AFFORDABLE HOUSING
DEVELOPMENT SSD-83256463
ARCHITECTURAL DRAWINGS
THE BOULEVARDE
PUNCHBOWL
COLLINS AND TURNER
SEPTEMBER 2025

No	Date	By	Note
B	9/12/2025	DC	For RTS

Project	
Affordable Housing Development SSD-83256463 150 The Boulevard and 34 Dudley Street Punchbowl, NSW

Drawing Title Section 1 and 2

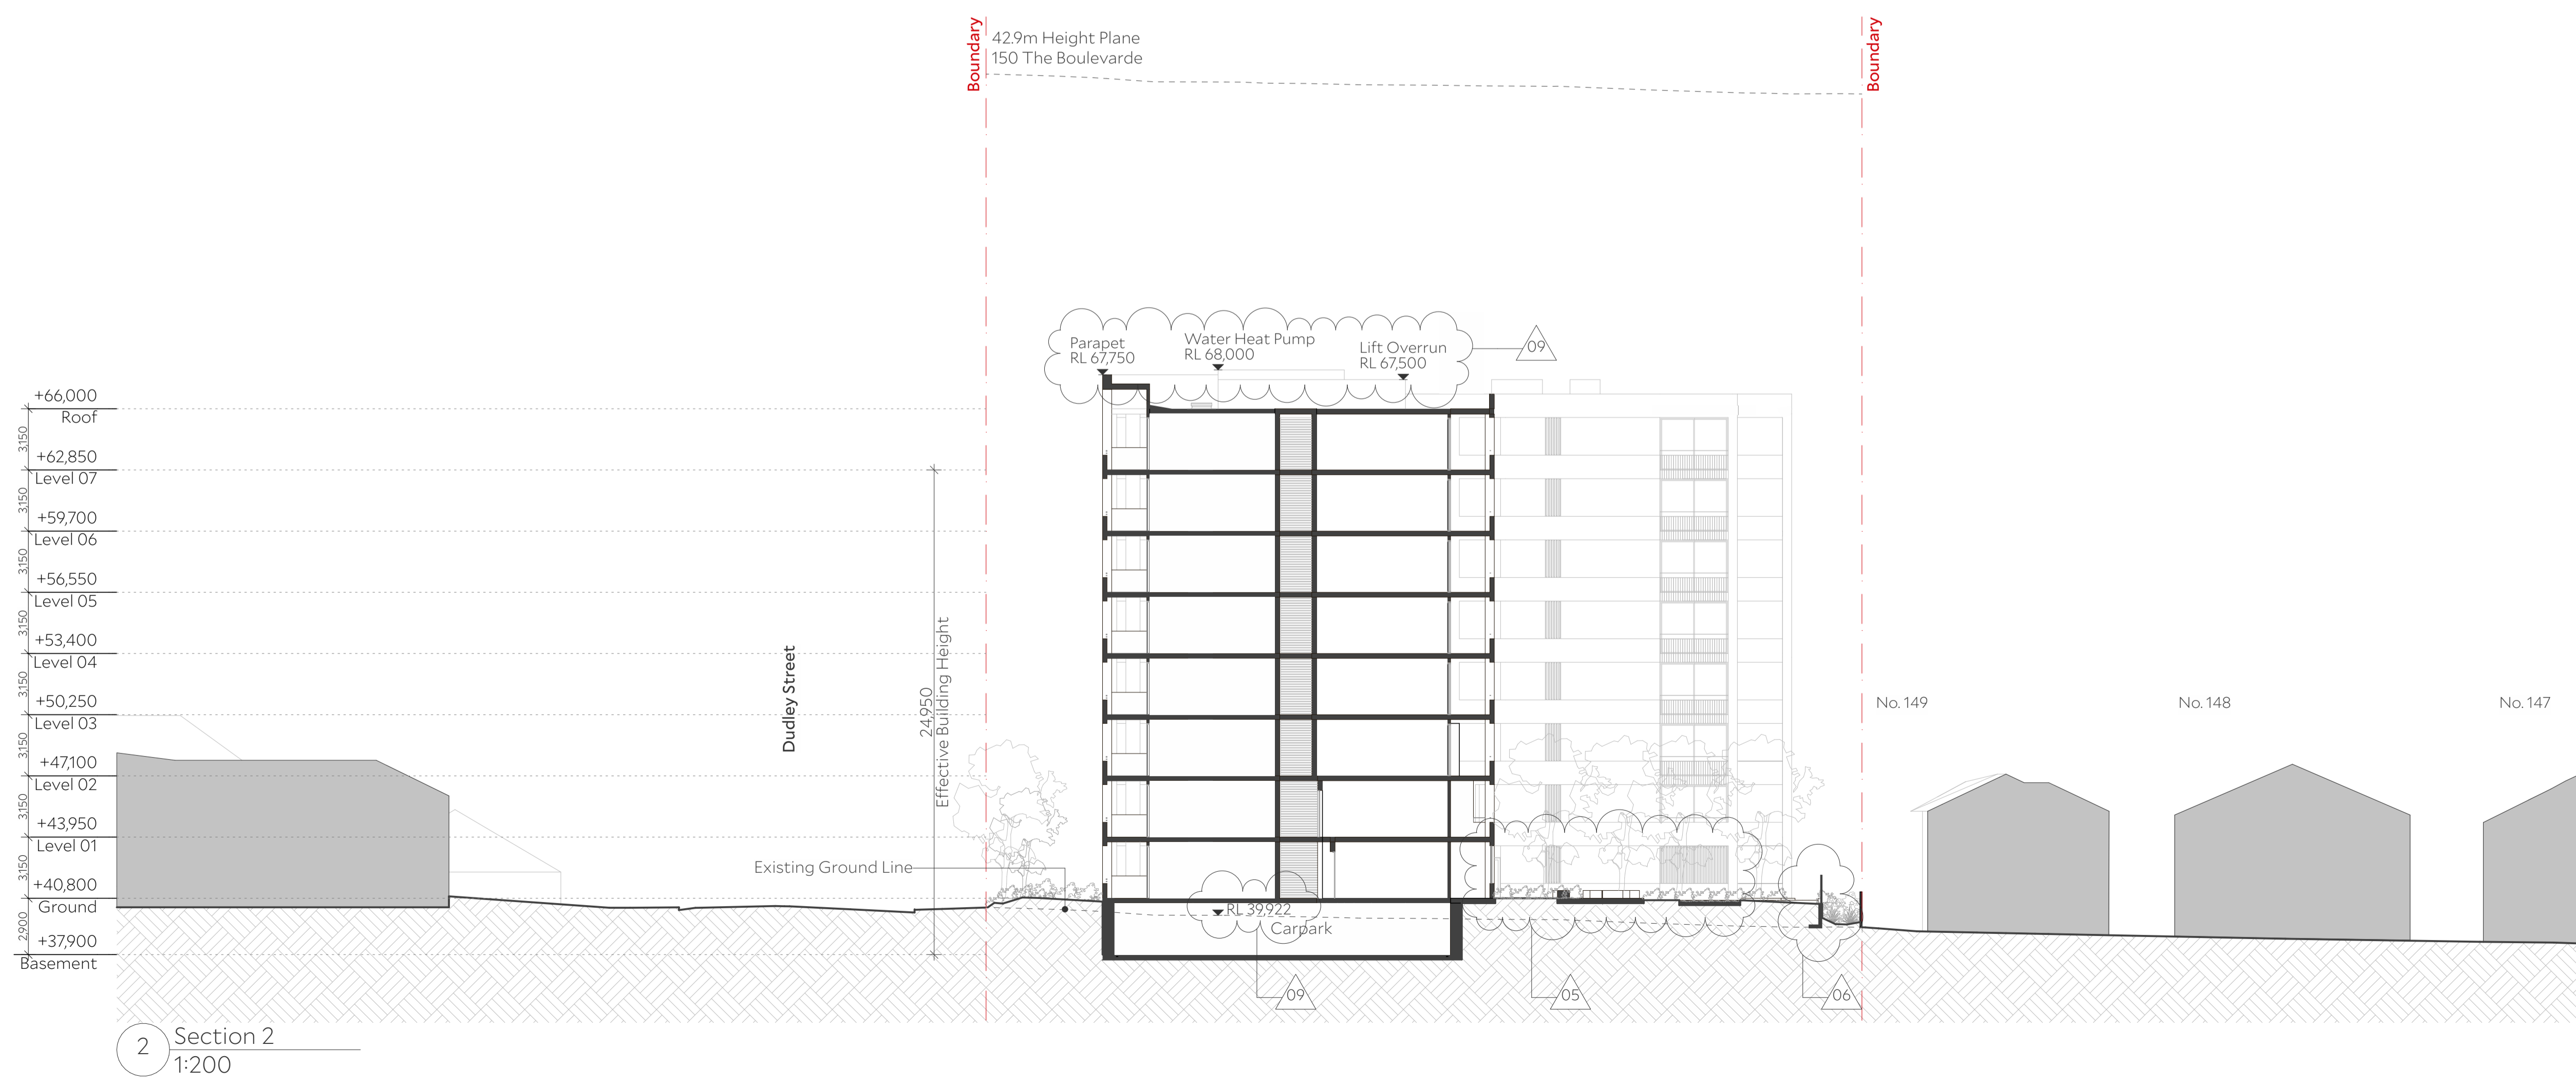
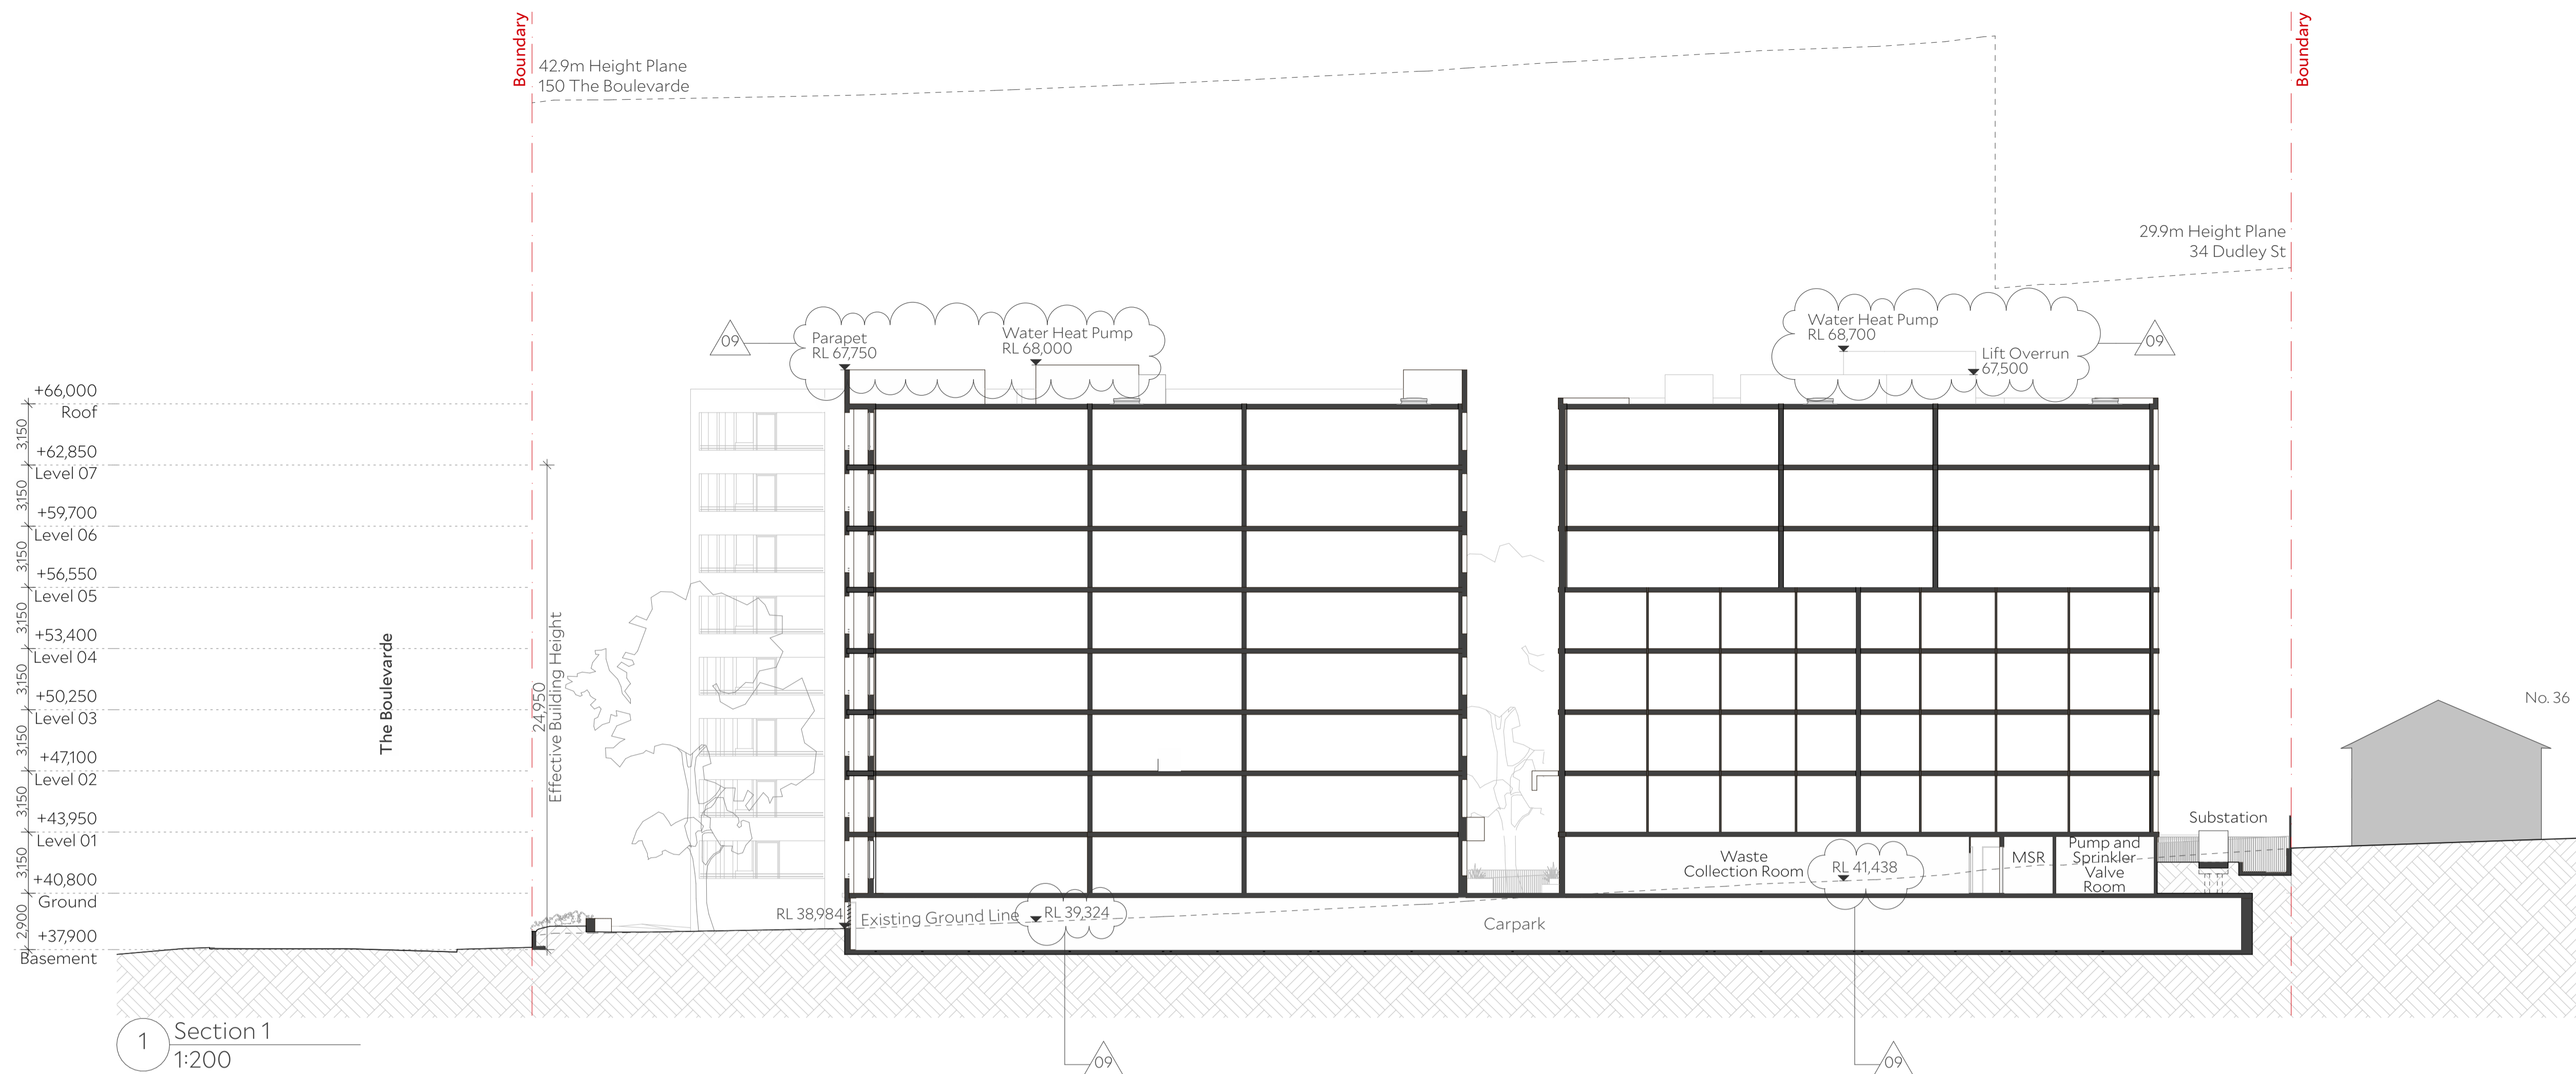
ID	Name
05	Privacy screens added and pathway repositioned Refer to RTS Item DPHI 7
06	Landscape privacy screen added Refer to RTS Item DPHI 8
09	Reduced levels added Refer to RTS Item DPHI 14
